RAI 03.07.02-29, Revision 1**QUESTION:**

RAI from Section 3.7 Audit, October 2010

REVISED RESPONSE:

Figure 03.07.02-29.68: Isometric View of the Box Structure (Element Aspect Ratio 1:1), Indicating the Nodes of Interest on Long Wall, Short Wall and Roof

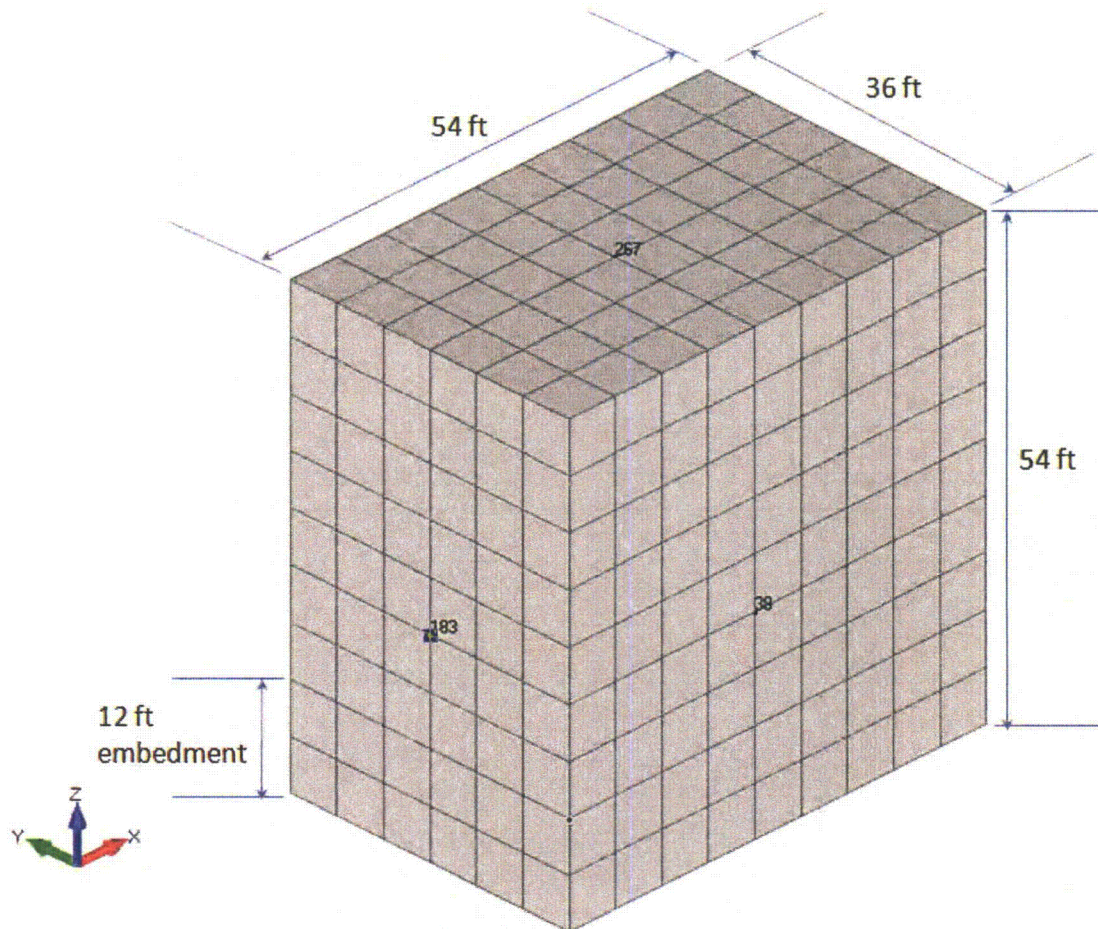
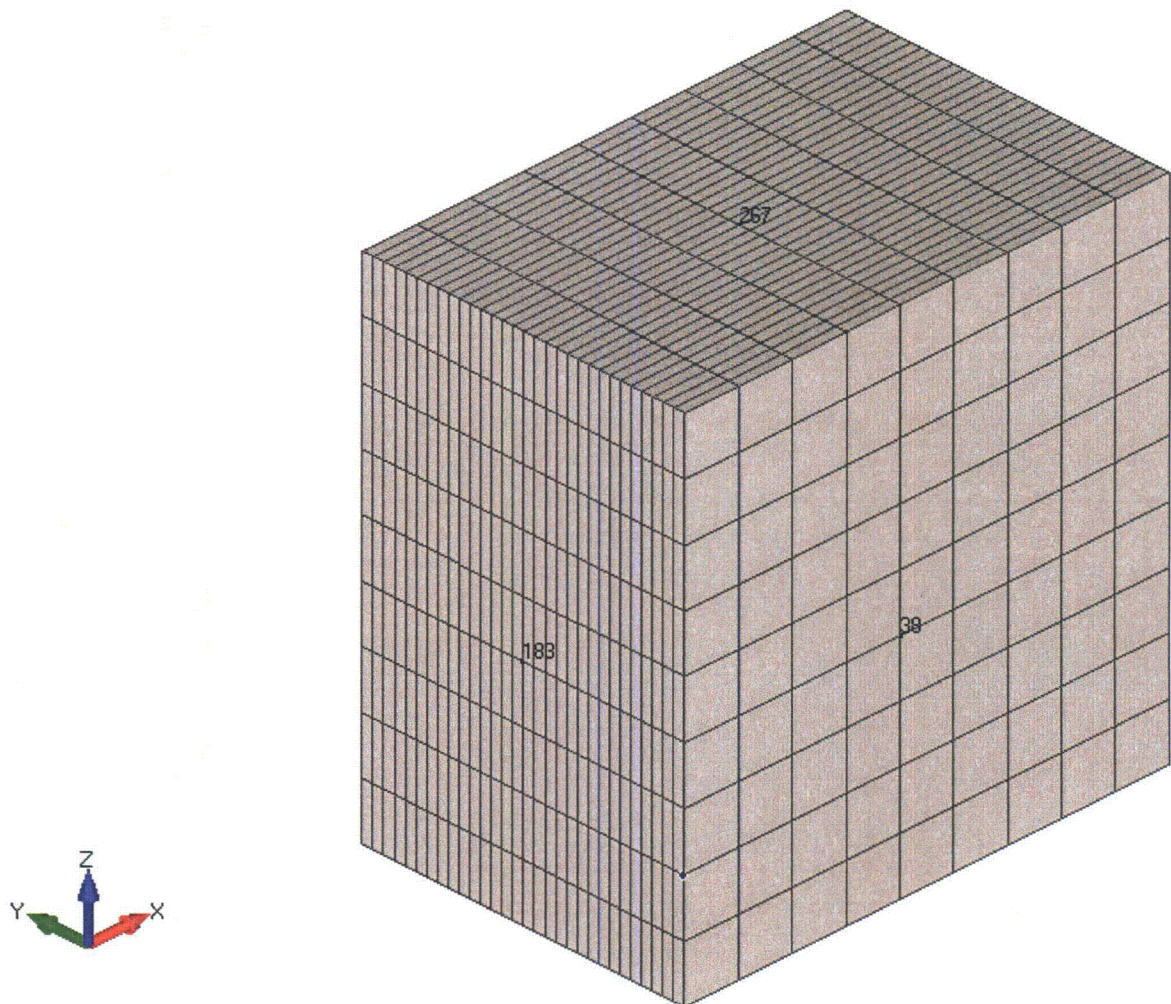
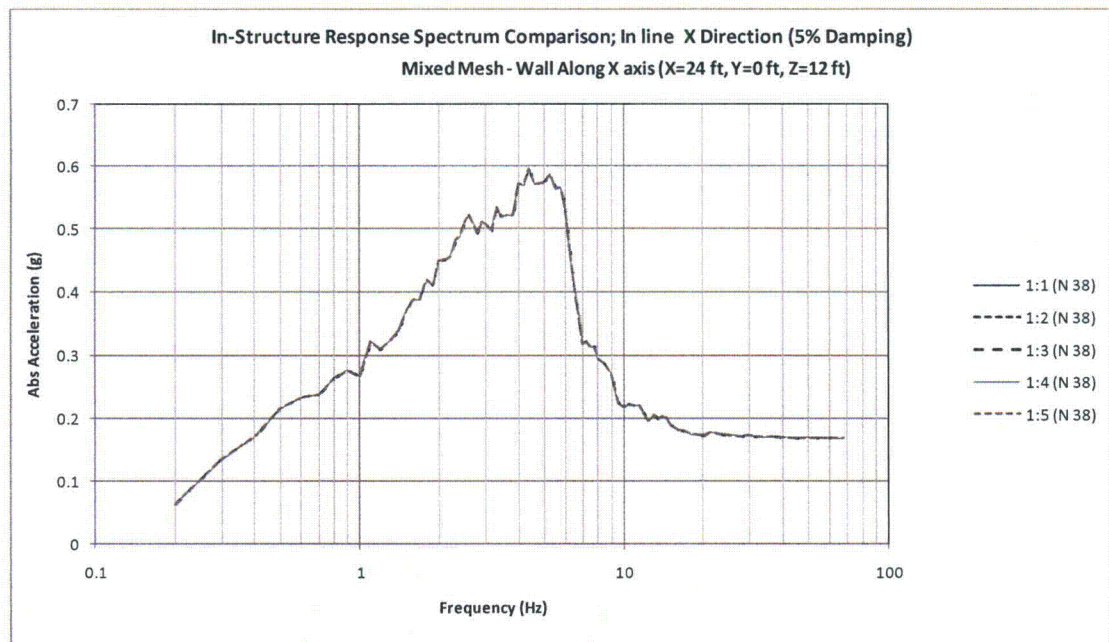
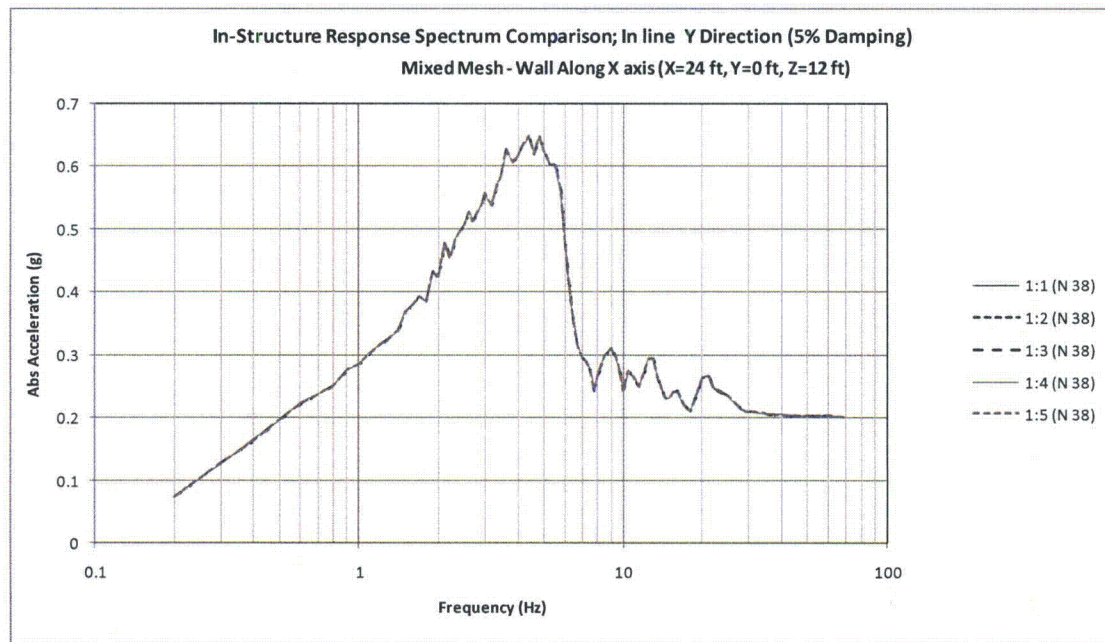
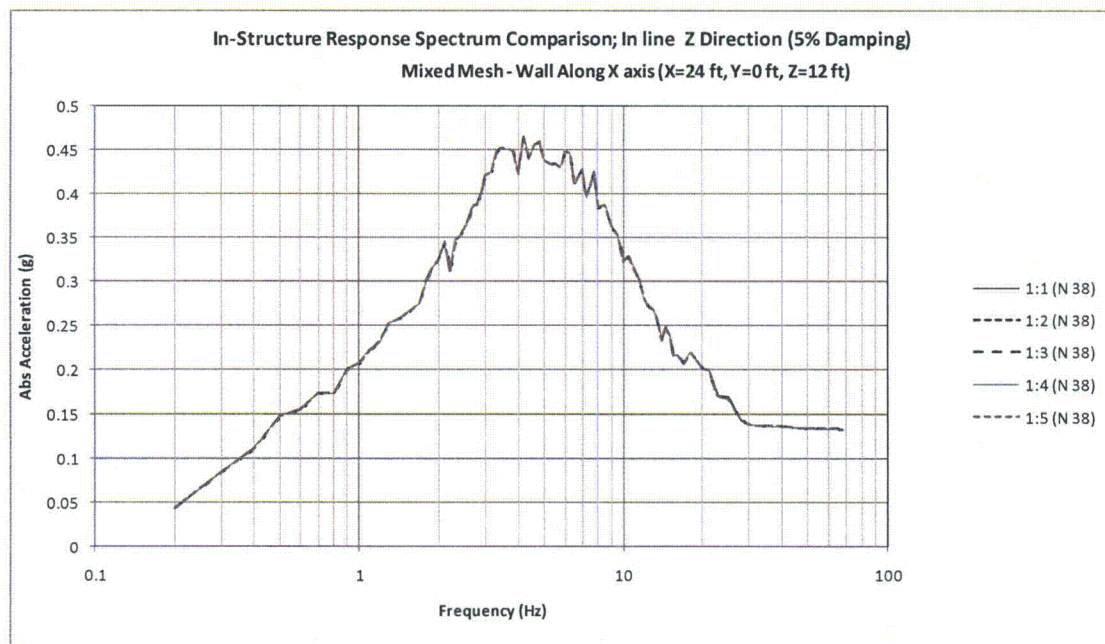
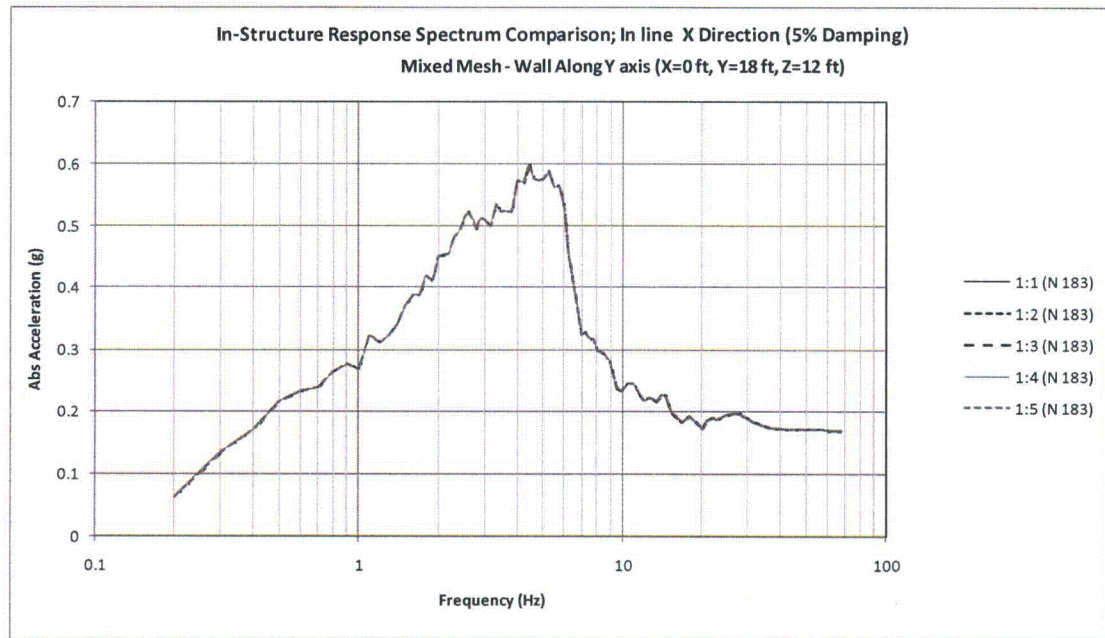
- **Acceptable aspect ratio of rectangular elements (solid, shell and plane-strain) to obtain accurate results, as used in the models**

The 1:1 and 1:5 models are shown in Figures 03.07.02-29.68 and 03.07.02-29.69 respectively and the excavation elements are shown in Figure 03.07.02-29.70. Other

Figures 03.07.02-29.71 to 03.07.02-29.82 show ISRS comparing the analyses with various element aspect ratios. All spectra compare very well for ratios 1:1 up to 1:5.

Figure 03.07.02-29.86: Finite Element Model of Slab Fixed on All Four Sides
(Slab dimensions are similar to one bay of STP Pump House Roof)

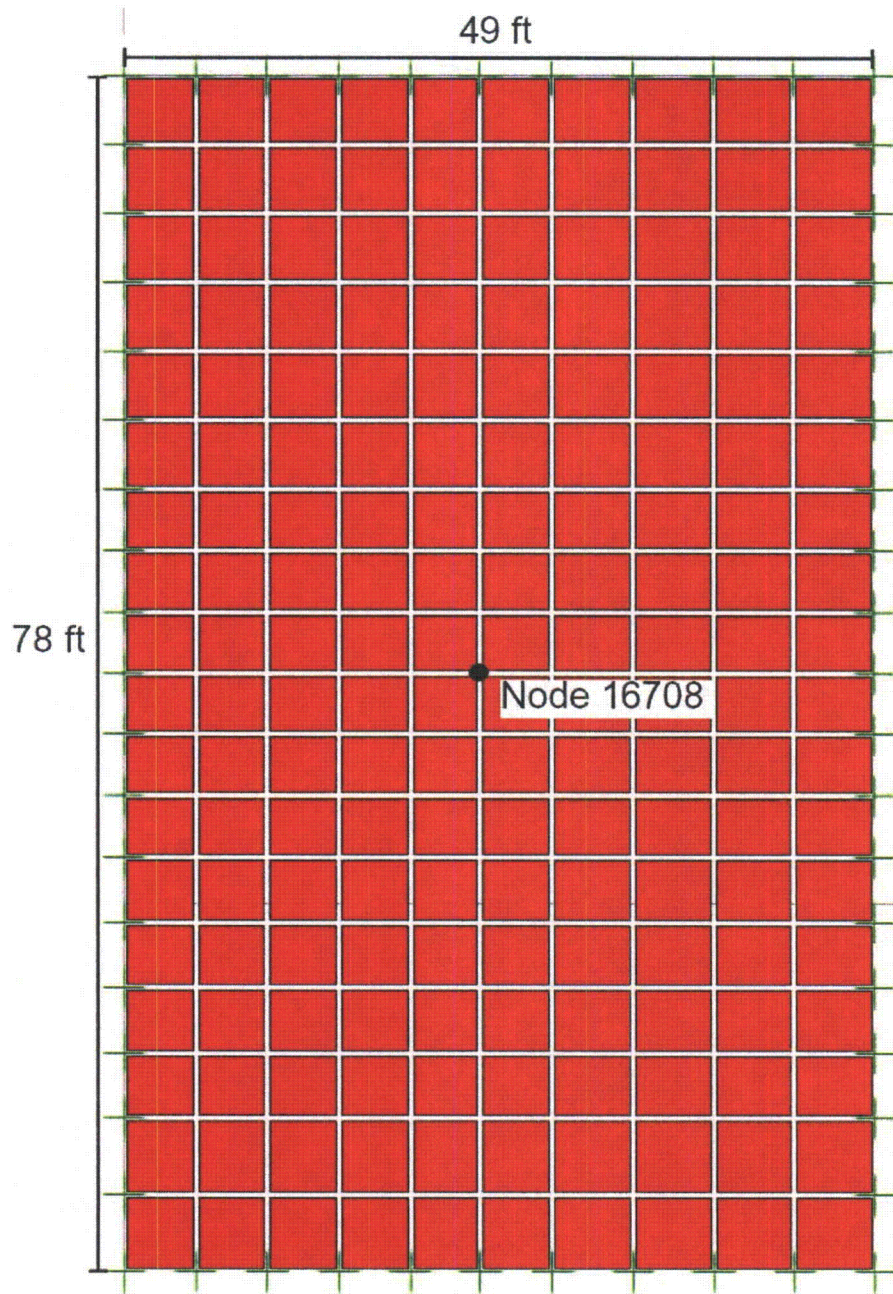
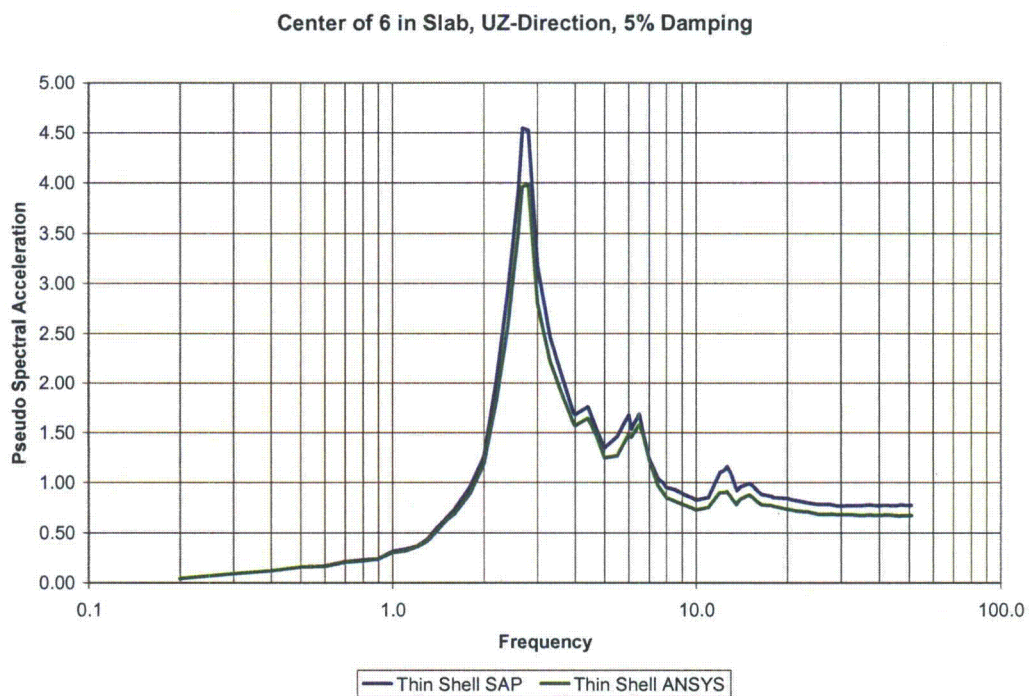
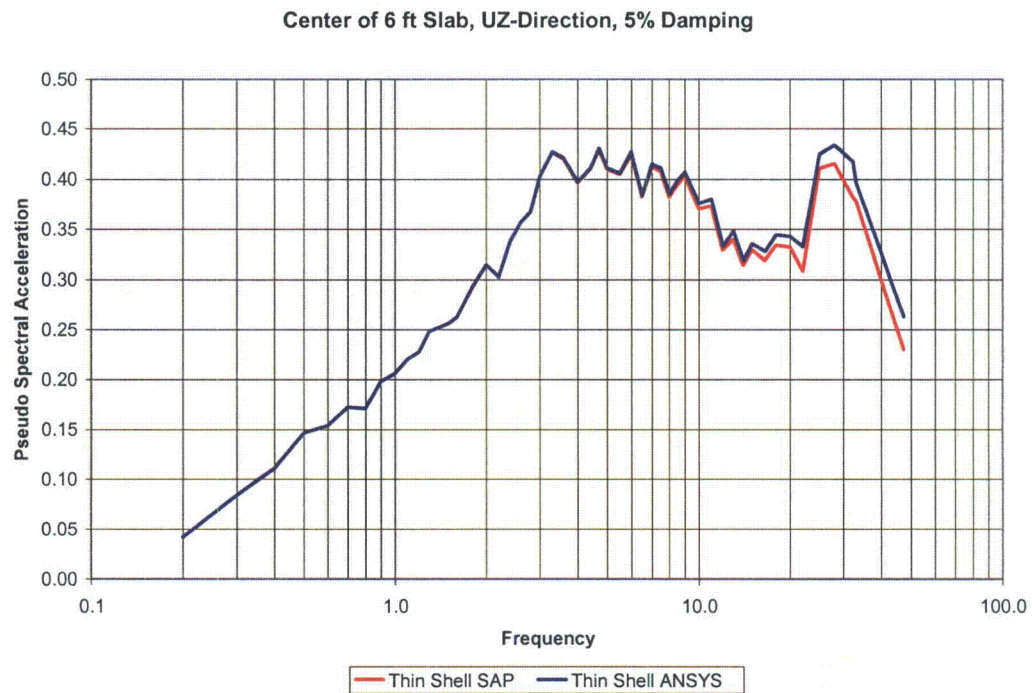
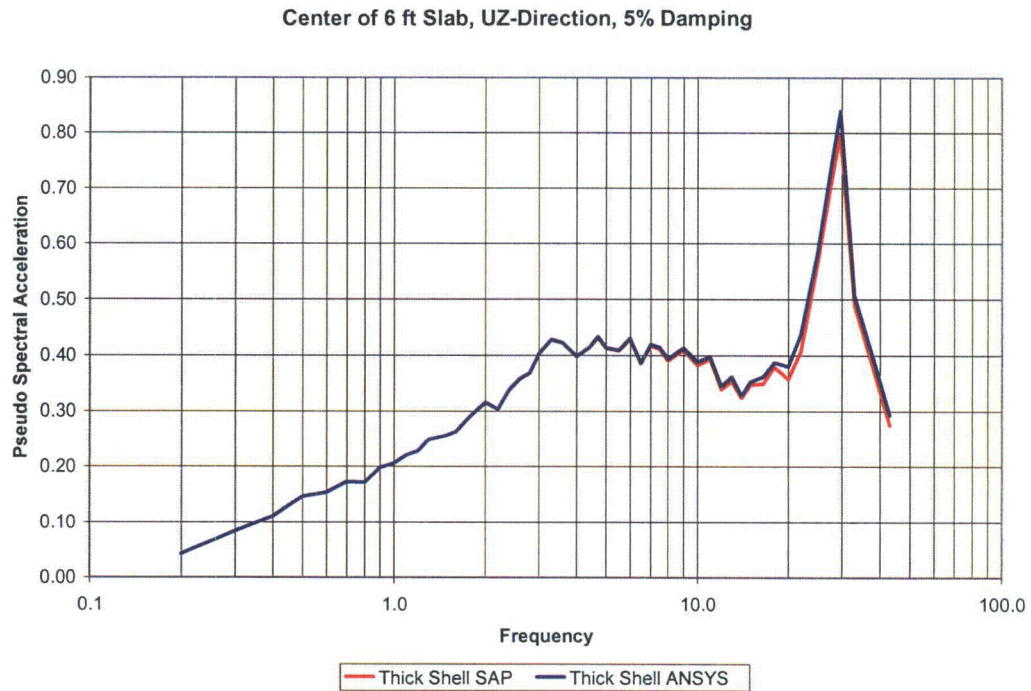
- **Validation of response spectra provided in Figures 03.07.02-25.10 and 03.07.02-25.11 of RAI 03.07.02-25, Revision 1, submitted concurrently with this response**

The spectra in Figure 03.07.02-25.10 and 03.07.02-25.11 were generated using the SAP2000 program for a 49 ft x 78 ft slab panel (similar to the STP Pump House roof slab panel), fixed on all four edges as shown in Figure 03.07.02-29.86. The model was analyzed for slab thicknesses of six inches and six feet, using both thin and thick shell formulations. Time history analyses of these slab models were performed by subjecting the models in the transverse direction with the vertical STP site-specific SSE base motion.

Comparison of the response spectra at the center of the six inch slab for thin shell elements is shown in Figure 03.07.02-29.87. As can be seen at about 2.7 hz, the acceleration from SAP2000 is about 15% higher than that from ANSYS.

Comparison of the response spectra at the center of the six inch slab for thick shell elements is shown in Figure 03.07.02-29.88. As can be seen at about 2.7 hz, the acceleration from SAP2000 is about 15% higher than that from ANSYS.

Comparison of the response spectra at the center of the six foot slab for thin shell elements is shown in Figure 03.07.02-29.89. As can be seen at about 28 hz, the acceleration from SAP2000 is about 5% lower than that from ANSYS.

Comparison of the response spectra at the center of the six foot slab for thick shell elements is shown in Figure 03.07.02-29.90. As can be seen at about 29.6 hz, the acceleration from SAP2000 is about 5% lower than that from ANSYS.
